ADDENDUM NO. 3, September 3, 2008

RE: Upper Cumberland Regional Health Facility
Cookeville TN
SBC Project No. 408/009-01-2004

FROM: Thomas Miller & Partners, LLC and
Upland Design Group Inc. – A Joint Venture
P. O. Box 1026 (38557)
362 Industrial Blvd.
Crossville, TN. 38555
Telephone: (931) 484-7541
Fax: (931) 484-2351

SITE PREPARATION & UTILITY PACKAGE UPPER CUMBERLAND REGIONAL HEALTH FACILITY COOKEVILLE, PUTNAM COUNTY, TENNESSEE SBC PROJECT NO. 408/009-01-2004-02				DRAWING	
I.C.Thomasson Associates, Inc. NASHVILLE TENNESSEE		JOB NO. 205401	SCALE NONE	DATE 9-5-08	MSK -01

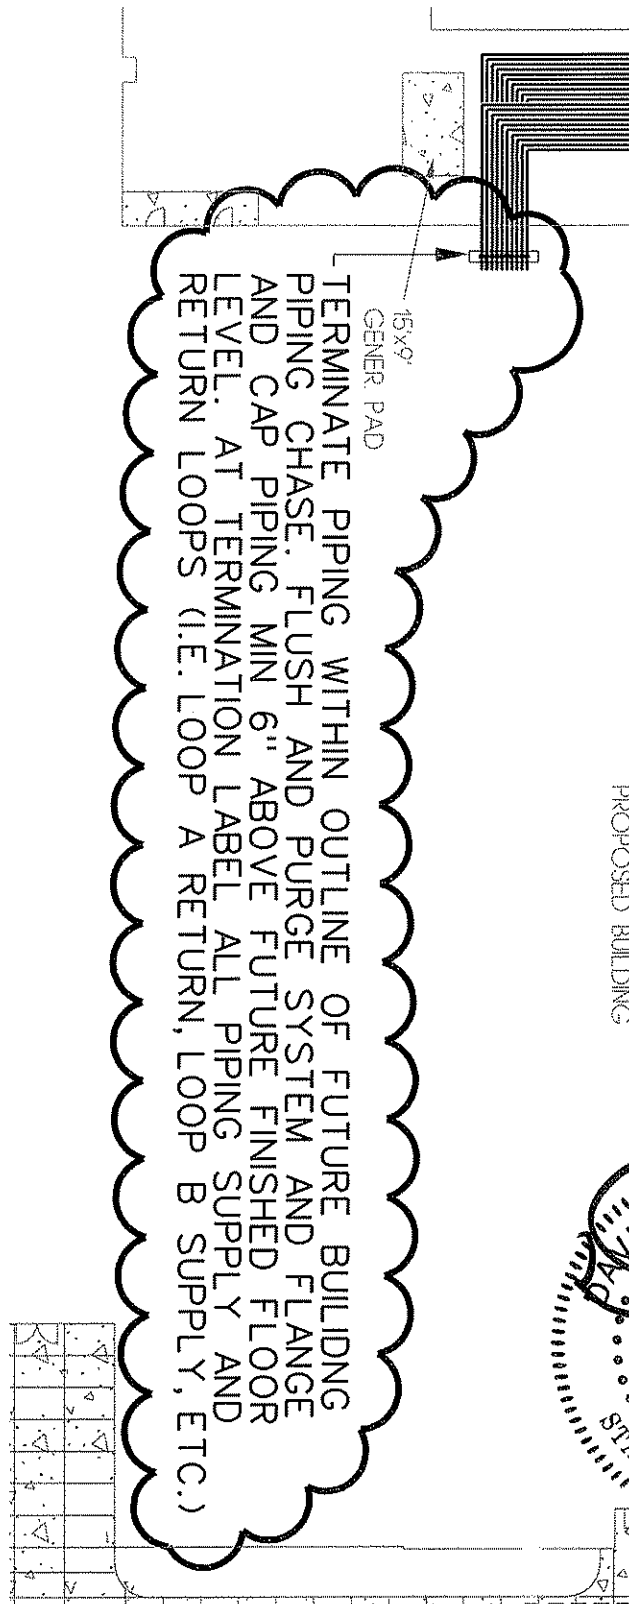
28. Refer to Drawing A2.1. Finish Schedule and Finish Legend. At all locations that call for GZB (glazed block) they shall be changed to CB (concrete block). There is no glazed block on the project.
29. Refer to Drawing A1.31 Details 1 & 2. Omit reference to "Graphic Copy supplied by Architect". There will be no graphic copy on the signs.
30. Refer to Drawings A4.1 thru A5.4. At all metal roof locations the wood underlayment shall be changed to 5/8" CDX plywood in lieu of the called for 7/16" OSB.
31. Refer to Drawing M210C. In space 255 the geothermal piping will be extended from the bore field into the building pipe chase by the early Site Preparation and Utility contractor as shown on attached drawing MSK-01 dates 9-5-08. MSK-01 is shown for reference only.
